Service Campaign 488 M161 MY21-22 - Potential Maserati Logo Detachment

DATE: April 5 2022

Maserati Levante (M161) MY21-22 vehicles are involved in a Service Campaign to prevent the detachment of the front hood Maserati EMBLEM.

Technical Procedure

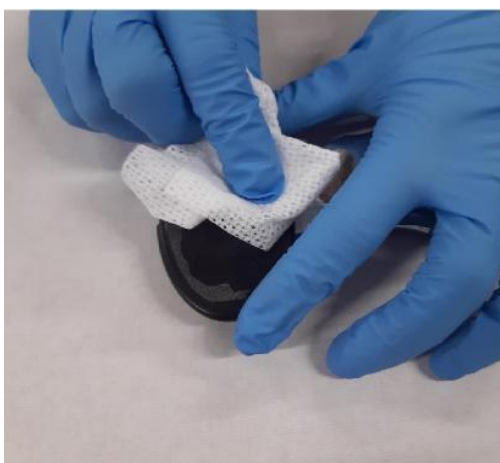
This event could occur due to insufficient coupling between the EMBLEM and its support, so the gluing could be compromised.

In case of poor connection, a special procedure has been developed to ensure optimal adherence and eliminate any risk of detachment of the Maserati EMBLEM.

1. Always check in ModisCS+ to see if the vehicle is involved in this campaign and if the campaign has not been previously performed.
2. Protect the area around the EMBLEM with masking tape.
3. Check if the Maserati EMBLEM can be easily detached from its holder using a suction cup or a suitable Teflon wedge. May need to apply little force for the inspection.

4. Remove the EMBLEM from the holder and clean the area between the holder and the EMBLEM with Isopropyl - alcohol wipes. Clean off all glue residue, then allow it to dry for 5 minutes.

6. Apply a bead of sealant, diameter 5 mm, length 25 mm, to the EMBLEM holder.

7. Carefully apply the painted aluminum EMBLEM on the plastic support holder and apply slight pressure with one hand. Make sure sealant does not squeeze out the sides of the EMBLEM.

8. After bonding and ensure proper curing:
- Do not open and close the hood for 4 hours
 - The vehicle can be moved within the shop only
 - Keep the car in a dry area (no rain!) at a minimum of 12°C (53.6°F) for at least 12 hours
9. Procedure is completed.
